SUBJECT : HASRPER CO., LTD.
FCC ID: O5XHL-320V
FCC Part 15 Subpart B Certification

FCC ID : O5XHL-320V
Model : HL-3210V

• Solution for EMI

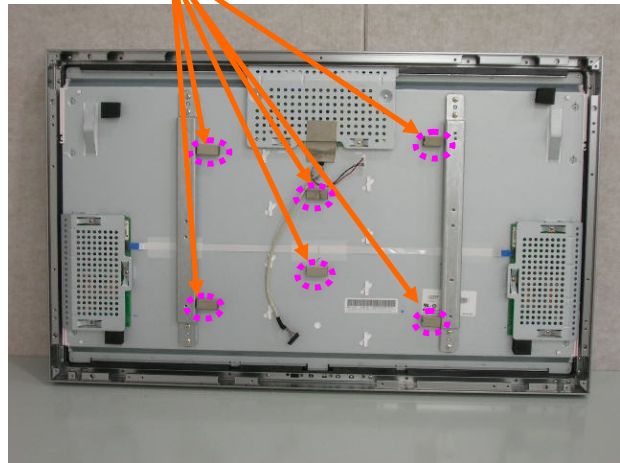
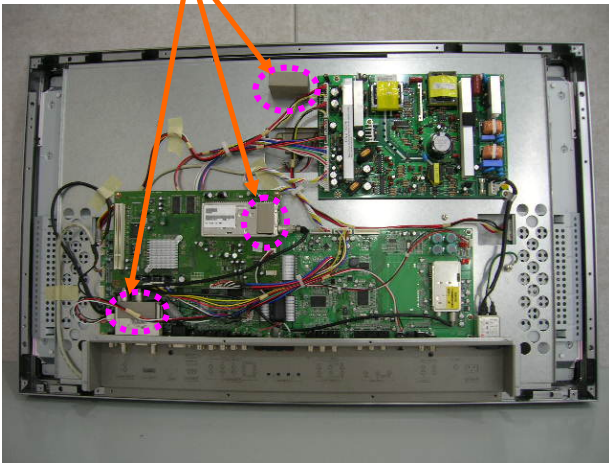
1. Attach a gasket on LCD panel back case and on TV Tuner

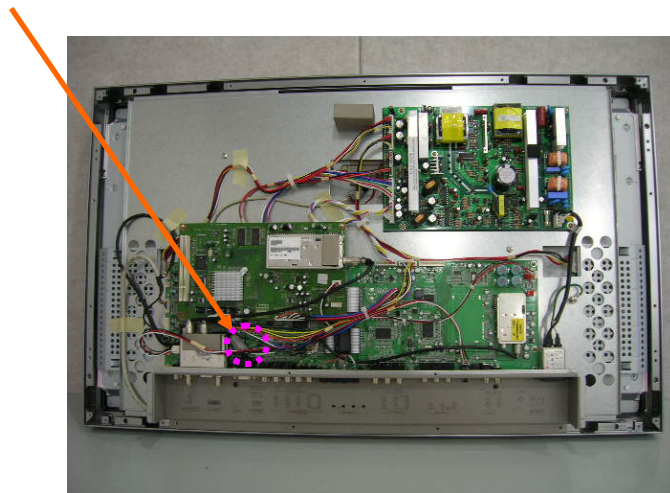
2. Apply a ferrite Core to the data cable

3. Apply a ferrite Core to the Speaker Cable
